**To:** Board of Zoning Appeals  
**From:** Planning and Urban Design Staff  
**Date:** March 13, 2023  
**Re:** Appeal BOZA2023-002

**Purpose:**  
This appeal has been filed to grant a variance from the front yard setback in the CP-2 District. Section 27-466(d)(1)a states that the front yard setback is 25 feet. The appellant is requesting a drive-thru canopy attached to the primary building that will create a front yard setback of 11 feet and 8 inches, a violation of 13 feet and four (4) inches.

**Property Location:**  
10770 Parallel Parkway  
Kansas City, Kansas 66109

# SITE PLAN DETAILS (C-210)

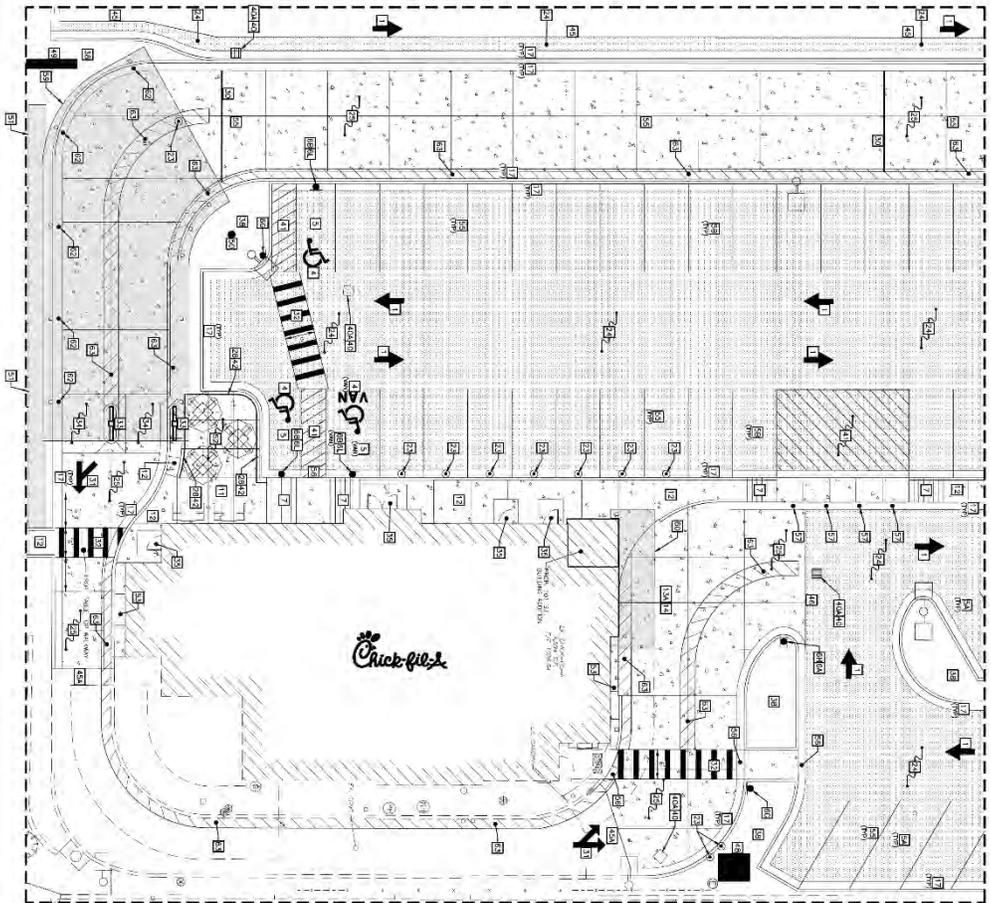
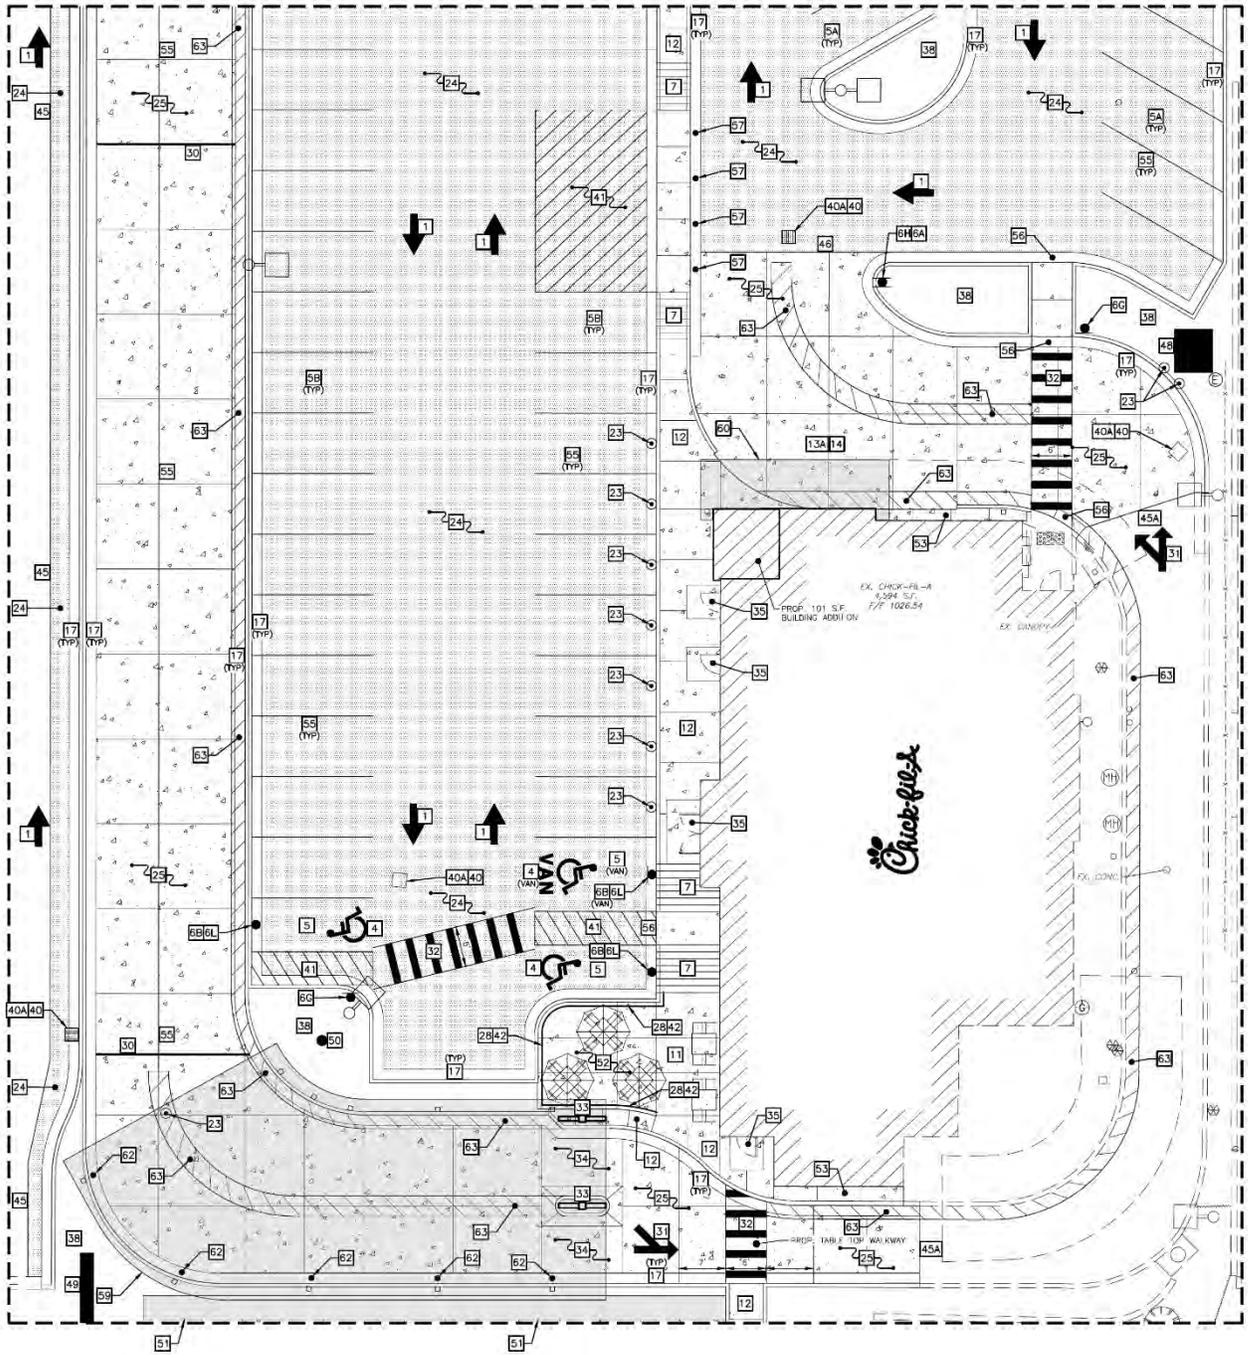
1. The applicant is requesting a Final Plan Review for a property zoned CP-2 Planned General Business District. Therefore, this property is subject to, and must comply with, all applicable regulations under the Commercial Development Guidelines Overlay District (CDGOD). This subsection addresses the applicant’s demonstrated compliance with relevant CDGOD regulations for PR2023-003. All listed requirements that are identified as “have not been meet” or “unclear if met” must be revised to be made compliant.
2. The following requirements of the Commercial Development Guidelines Overlay District have been met:
  - a. Section 27-575(a)(2) states the parking and circulation should account for pedestrians, bicycles, and vehicles. This circulation pattern, per Section 27-575(d)(8), shall connect in a way that is obvious to users;

*Applicant Response: The site has been designed to promote drive thru circulation and site movability for vehicles, pedestrians, and bicycles. The site will have directional signage and pavement markings to provide obvious intended directional routes. See Sheets C-200 & C-210.*

Staff Response: A revised site plan demonstrating an improved circulation pattern has been received by Staff. Sheets C-200 and C-210 can be found under “Site Plan of 10770 Parallel Parkway (C-200)” and “Site Plan Details (C-210)”, respectively, within the *Attachments* section of this report.

# LANDSCAPING PLAN OF 10770 PARALLEL PARKWAY (L-100)

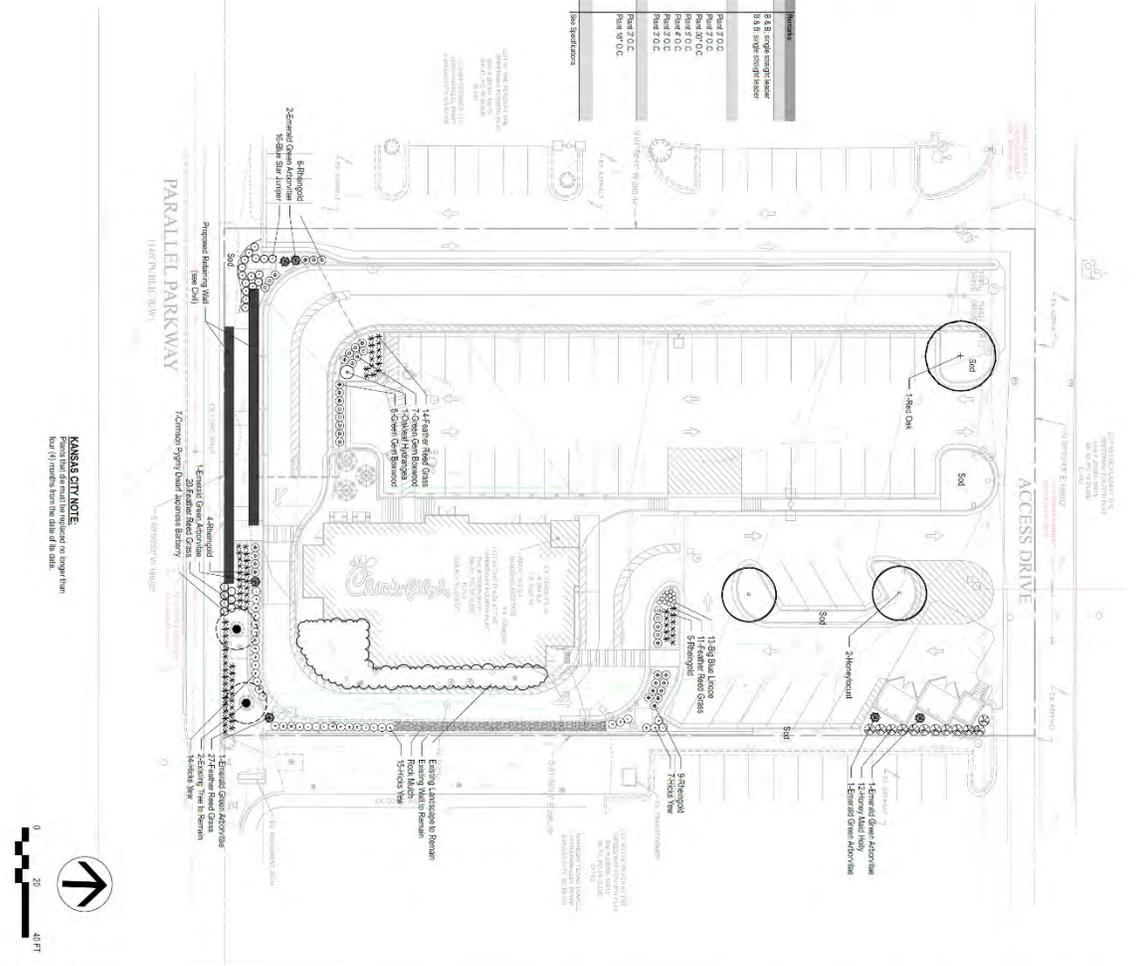
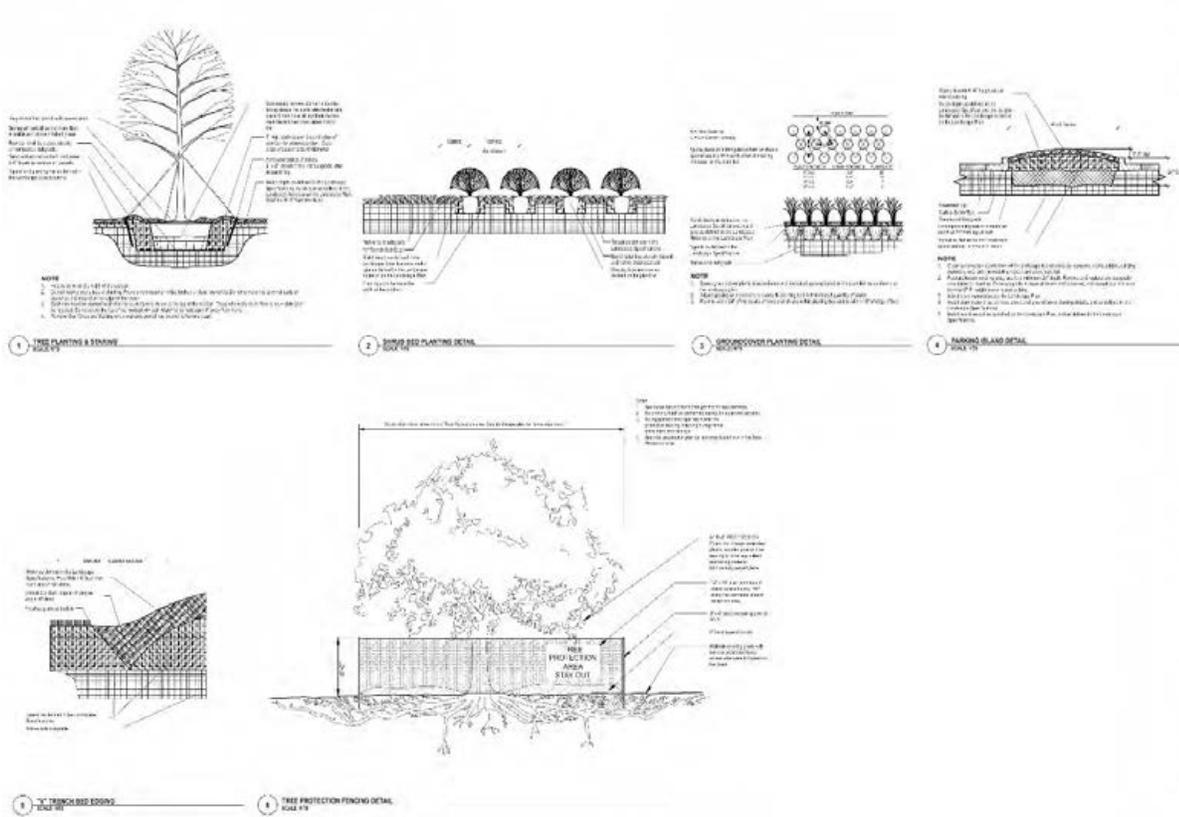
3. A landscaping plan that sufficiently demonstrates the addition of landscaping and vegetation in order to make up for the existing landscaping to be removed as part of the drive-thru lane expansion; and,

- h. Section 27-577(b)(3)(a) states that one tree with a minimum caliper of two inches (ornamental) evergreen trees must be at least six feet tall when planted) provided for every 30 feet of street easement or frontage;

- i. Section 27-577(d)(1) states that at least 75 percent of the length of building foundations facing public streets, the exterior of the development, or common spaces must be planted with ornamental plant material such as ornamental trees, flowering shrubs, perennials, and groundcovers;

- k. Section 27-577(f)(2) states that plants that die must be replaced no longer than four (4) months from the date of its death.

- a. Section 27-577(b)(3)(b) states that street trees should be planted no closer than 55 feet and no more than 65 feet apart with groupings or ornamental trees and shrubs placed between them.

*Applicant Response: A revised landscaping plan has been provided as requested. See Sheet L-100.*

Staff Response: A revised landscaping plan has been received by Staff. Sheet L-100 can be found under “Landscaping Plan of 10770 Parallel Parkway (L-100)” within the *Attachments* section of this report.

*Applicant Response: Plan revised to show and note required street frontage trees along Parallel Parkway on sheet L-100.*

Staff Response: A revised landscaping plan demonstrating the requisite trees has been received by Staff. Sheet L-100 can be found under “Landscaping Plan of 10770 Parallel Parkway (L-100)” within the *Attachments* section of this report.

*Applicant Response: Plan revised to show existing foundation landscape to remain on sheet L-100.*

Staff Response: A revised landscaping plan demonstrating the landscaping to remain has been received by Staff. Sheet L-100 can be found under “Landscaping Plan of 10770 Parallel Parkway (L-100)” within the *Attachments* section of this report.

*Applicant Response: Comment added as note #1 for "Kansas City Note" added to sheet L-100.*

Staff Response: A revised landscaping plan demonstrating the comment has been received by Staff. Sheet L-100 can be found under "Landscaping Plan of 10770 Parallel Parkway (L-100)" within the *Attachments* section of this report.

*Applicant Response: Plan revised to show trees no more than 65 feet apart except along proposed drive-thru canopy due to conflicts on sheet L-100.*

Staff Response: While a revised landscaping plan has been received by Staff, the inability for trees to be planted along the entirety of the frontage of Parallel Parkway requires a deviation from the City Planning Commission. Sheet L-100, demonstrating the revised landscaping plan, can be found under "Landscaping Plan of 10770 Parallel Parkway (L-100)" within the *Attachments* section of this report.

# FLOOR PLAN OF 10770 PARALLEL PARKWAY (G-003)

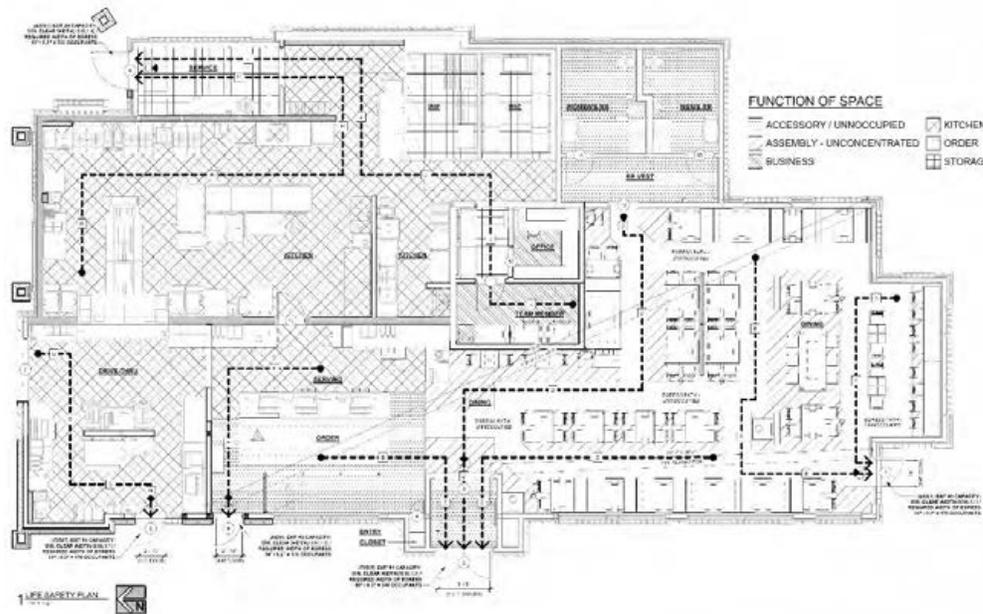
4. A floor plan of the building, demonstrating the square footage of the space designated for dining and the square footage of the space for all other uses.

*Applicant Response: A floor plan of the building depicting square footages has been provided as requested. See Sheet C-003.*

Staff Response: Sheet C-003 has not be received by Staff, but Sheet G-003 can be found under “Floor Plan of 10770 Parallel Parkway (G-003)” within the *Attachments* section of this report. The floor plan demonstrates 2,000 square feet of dining space and 2,532 square feet of remaining space.

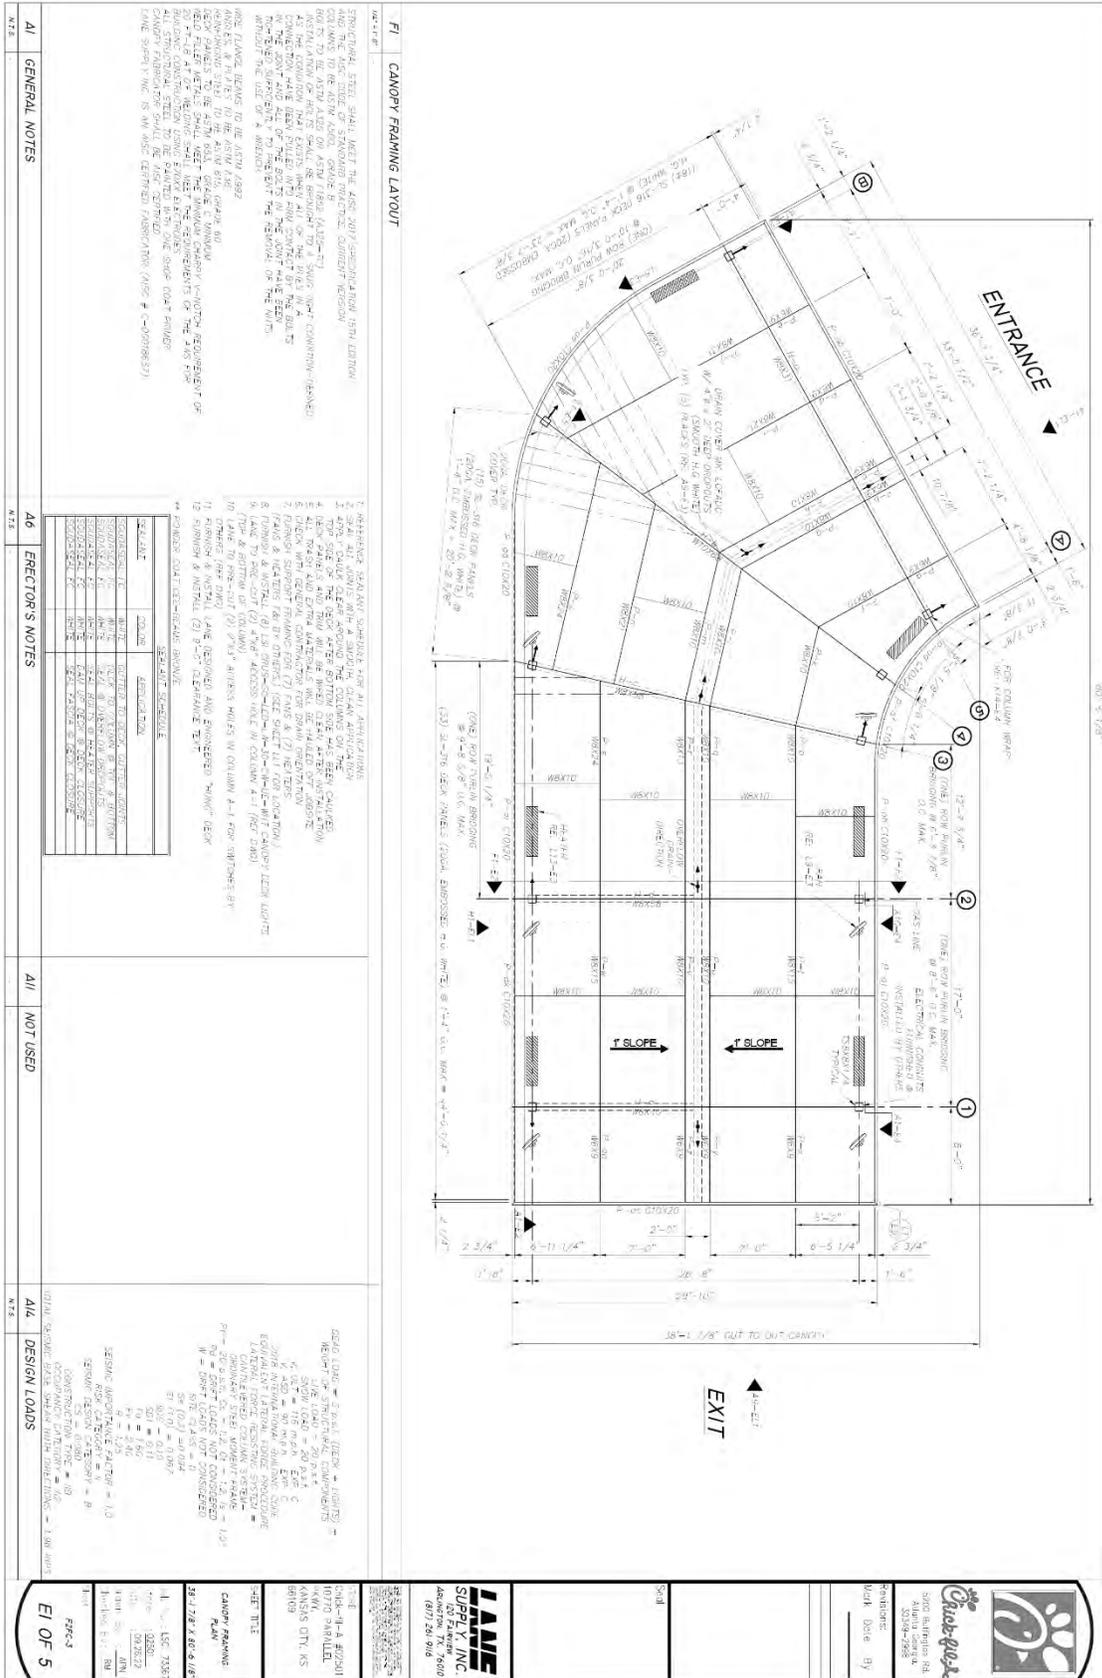
2. The canopy plan has been provided. Applicant must also provide documentation of the canopy material palette. Note that canopy pillars shall be of a masonry material.

*Applicant Response: Color elevation renderings of the building and canopy have been provided as requested. The elevations depict the masonry material that will*

*be installed on the canopy pillars. The canopy itself will consist of metal material in dark bronze color.*

Staff Response: Elevations of the building and canopy, and a digital materials palette for the canopy, have been received by Staff. Elevations for the building can be found under “Building Elevations Submitted by the Applicant”, elevations for the proposed canopy can be found under “Canopy Elevations Submitted by the Applicant”, and the materials palette for the canopy can be found under “Materials Palette Submitted by the Applicant”; all of which are located within the *Attachments* section of this report.
